Access Compliance Report

Public Rights-of-Way

Intersection ID: 16805	Main Street: N_SHARON_AMITY_RD	Cross Street: KELLY_ST	Location: SW
ADA ID: B1616408FF33	Ramp Type: ParaDiag	Initial Pass/Fail: Fail	Overall Compliance: No
Severity Score: 37.5			
Codes/Mitigation Info/Possible Solution		Field Measurements/Component Compliance

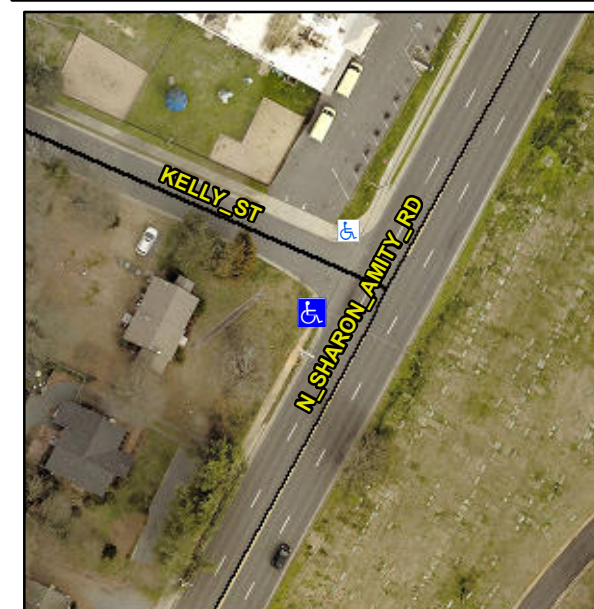
R304.3.2, R304.5.3

Compliance	Description	Data	Compliance	Description	Data
N/A	Ramp Length LT (in)	54.0	N/A	Ramp Length RT (in)	60.0
Yes	Ramp Width LT (in)	60.0	Yes	Ramp Width RT (in)	60.0
No	Ramp Slope LT (%)	12.6	Yes	Ramp Slope RT (%)	5.8
No	Ramp XSlope LT (%)	5.7	Yes	Ramp XSlope RT (%)	0.6
N/A	Landing Length (in)	N/A	N/A	DWS Provided?	N/A
N/A	Landing Width (in)	N/A	N/A	DWS Contrast?	N/A
N/A	Landing Slope (%)	N/A	N/A	DWS Length (in)	N/A
N/A	Landing X Slope (%)	N/A	N/A	DWS Full Width?	N/A
N/A	Landing Curb? (Y/N)	N/A	N/A	DWS Offset (in)	N/A
N/A	Shared Landing?	N/A			
N/A	Gutter Ponding?	N/A	N/A	Gutter Slope (%)	N/A
N/A	Gutter Lip Ht (in)	N/A	N/A	Gutter X Slope (%)	N/A
N/A	Painted X Walk1?	No	N/A	Painted X Walk2?	No
	X Walk 1 Direction	To SE		X Walk 2 Direction	To NE
N/A	X Walk 1 Width (in)	N/A	N/A	X Walk 2 Width (in)	N/A
	X Walk 1 Slope (%)	5.4		X Walk 2 Slope (%)	3.3
	X Walk 1 X Slope (%)	3.1		X Walk 2 X Slope (%)	12.0
N/A	Ramp inside XWalk1?	N/A	N/A	Ramp inside XWalk2?	N/A

Road Slope (%)	8.1	N/A	Clear Space?	N/A
	Road X Slope (%)	18.3	N/A	Clear Space to XWalk (in)	N/A
N/A	Any Obstructions?	N/A	N/A	Storm Grate/Utility Hazard?	N/A
	Obstruction Type			Storm Grate/Utility Type	
		N/A			N/A
			Yes	Surface Condition? (G/P)	Good
			N/A	Curb Slope (%)	10.1

Remove & Replace Curb Ramp With Two New Directional Ramps or Equivalent.
